Road Safety Audit Report

Incorporating
Stage 1 Completion of Preliminary Design;
Design Organisation Response to items raised.

Proposed Priority Access off Chalcraft Lane Bersted

Job no	RSA-20-068	Issue no	3	Date	September 2020
Prepared by	JJF	Verified by	FB	Approved by	JJF
Filename and Path	Fenley/Road Safety Audits/RSA-20/RSA-20-068-3

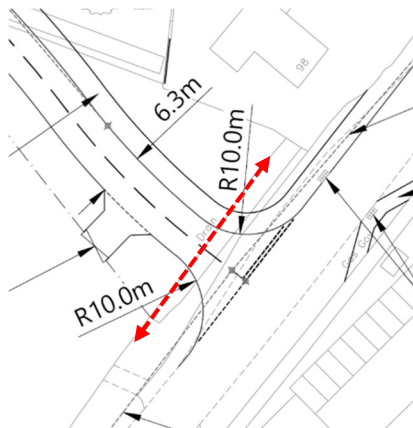
A.1	LOCAL ALIGNMENT
	<i>No Road Safety Concerns regarding LOCAL ALIGNMENT have been raised at this stage</i>
A.2	GENERAL
A.2.1	PROBLEM
Location:	Proposed access, Chalcraft Lane
Summary:	Existing road gully will be within the path of vehicles
Acc Type:	Loss of control
Chalcraft Lane benefits from a network of road gullies that provide for the drainage of surface water that accumulates on the carriageway. Following implementation of the proposed access, a pair of existing gullies will be situated within the path of a vehicle or cyclist approaching and entering the proposed access. A road gully within the path of a vehicle could give rise to loss of control type incidents especially for two wheeled vehicles and vehicles undertaking a braking manoeuvre.	
RECOMMENDATION:	
It is recommended that the gullies are relocated and an adequate surface water drainage network is provided.	
Location Plan:  	
DESIGN ORGANISATION RESPONSE provided by i-Transport on the 8th September 2020 following formal issue of this Stage 1 Road Safety Audit on the 7th September 2020

Accepted – to be addressed as part of the S278 Detailed Design.	
A.2.2	PROBLEM
Location:	Proposed access
Summary:	A ditch and number of outlets / headwalls are present within the area of the works
Acc Type:	Vehicle loss of control
A drainage ditch is present along the northern side of Chalcraft Lane that accommodates a number of headwalls and outlets from the network of road gullies that are situated along the channel line and allow surface water for the drainage of surface water. The proposals provide a priority junction

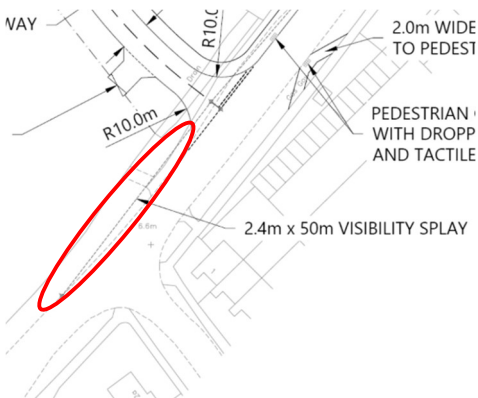
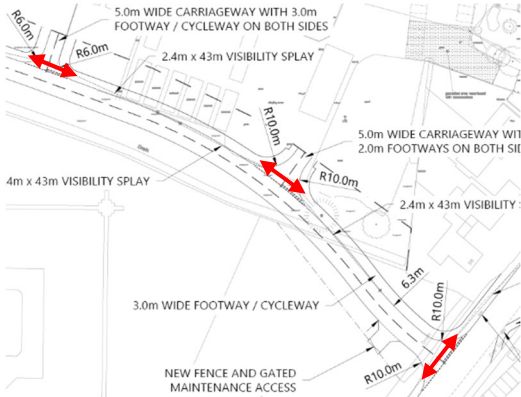
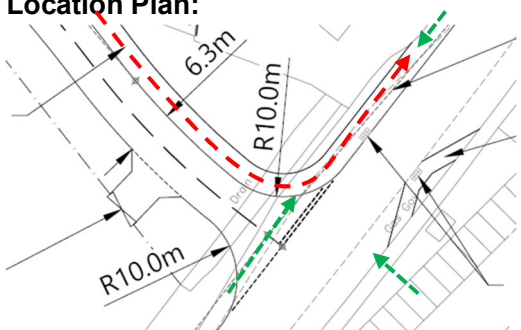
Location: Proposed access, northern verge of Chalcraft Lane

Summary: Foliage within the verge to the south of the proposed access restricts visibility

Acc Type: Side impact and rear end collision

Chalcraft Lane forms part of a primary route between North Bersted and Aldwick and is subject to a 30mph speed limit. The proposals include the provision of a simple priority access off the northern side of the carriageway from which the scheme drawing illustrates that 2.4 x 50 metre visibility splays are achievable in accordance with the 30mph speed limit of the road. However, the verge along the southern side of the proposed access is overgrown with foliage encroaching the carriageway in places. The tree canopies and vegetation will restrict visibility to and from a vehicle exiting the proposed simple priority access which could give rise to side impact or rear end collision when a vehicle proceeds when it is not safe to do so.

It is recommended that the appropriate visibility splays are maintained clear and free of obstructions.

Location Plan:  	
DESIGN ORGANISATION RESPONSE provided by i-Transport on the 8th September 2020 following formal issue of this Stage 1 Road Safety Audit on the 7th September 2020	
Accepted – vegetation encroaching within the visibility splay to be cut back as part of the site access work. On-going maintenance of vegetation within the highway is a statutory responsibility of the local highway authority.	
A.4	WALKING CYCLING AND HORSE RIDING
A.4.1	PROBLEM
Location:	Chalcraft Lane and Proposed access road
Summary:	Full height kerbs will be an obstruction to pedestrians especially the mobility impaired
Acc Type:	Vehicle pedestrian and pedestrian trips and falls
Ffairfach Close provides access to the existing commercial development off Chalcraft Lane where pedestrians are required to walk in the carriageway. The proposals provide a spine road accessed off a simple priority junction with Chalcraft Lane and accommodates two priority accesses off the northern side that are to serve a commercial development and 20 dwellings. A shared footway / cycleway is provided along the northern side of the proposed carriageway that allows cyclists and pedestrians to join the existing footway along the northern side of Chalcraft Lane; however, the scheme drawings do not identify that dropped kerbs are to be provided where users are required to cross the proposed accesses. Whilst full height kerbs will become an obstruction to pedestrians particularly the mobility impaired or those walking with buggies and children on a scooter, the lack of a tactile warning could result in a visually impaired pedestrian entering the carriageway when it is not safe to do so which raises the risk of a vehicle-pedestrian collision.

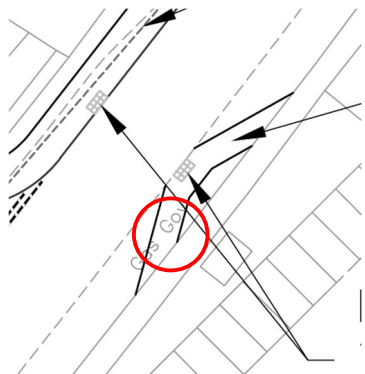
Location: Proposed crossing point, southern footway Chalcraft Lane

Summary: Existing street lighting column will become an obstruction to pedestrians

Chalcraft Lane benefits from street lighting with a number of street lighting columns located within the existing verge to the east of the carriageway. The proposals provide a 2.0-metre footway link from the existing footway to a proposed uncontrolled crossing point on Chalcraft Lane. The Audit Team observed that an existing streetlight column may be situated at this location which will be located within the proposed footway and be an obstruction to pedestrians. Such an obstruction could be struck by a pedestrian or force one to enter the carriageway suddenly raising the risk of vehicle collisions with pedestrians as well as trips and falls.

It is recommended that the street lighting column is relocated out of the footway

Accepted – crossing point has been relocated as to avoid conflict with lighting column (see drawing ITB14224-001 Rev C).

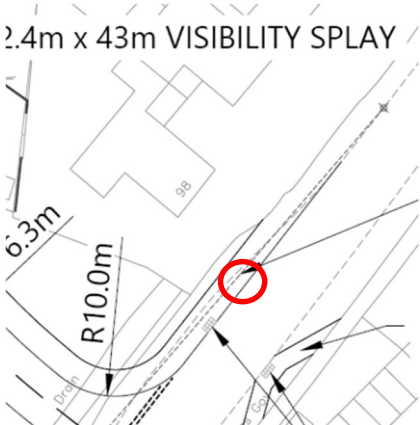
Location: Proposed footway / cycleway, northern footway

Summary: Services covers will be an obstruction

Chalcraft Lane accommodates a number of utility covers within the existing footway, verge, and carriageway. The proposals include the provision of a priority access off the western side of Chalcraft Lane that accommodates a 3.0-metre footway cycleway along the northern radius which ties into the local pedestrian network. The scheme stops up an existing parking bay situated along the western side of the Chalcraft Lane carriageway where a number of the utility covers are present and will be located within the footway following the works. Raised or sunken utility covers along a pedestrian desire line, will be an obstruction and trip hazard.

It is recommended that service covers are adjusted or relocated accordingly.

Location Plan: 2.4m x 43m VISIBILITY SPLAY  	
DESIGN ORGANISATION RESPONSE provided by i-Transport on the 8th September 2020 following formal issue of this Stage 1 Road Safety Audit on the 7th September 2020	
Accepted – to be addressed as part of the S278 Detailed Design.	
A.5	ROAD SIGNS, CARRIAGEWAY MARKINGS AND LIGHTING
	<i>No Road Safety Concerns regarding ROAD SIGNS, CARRIAGEWAY MARKINGS AND LIGHTING have been raised at this stage</i>
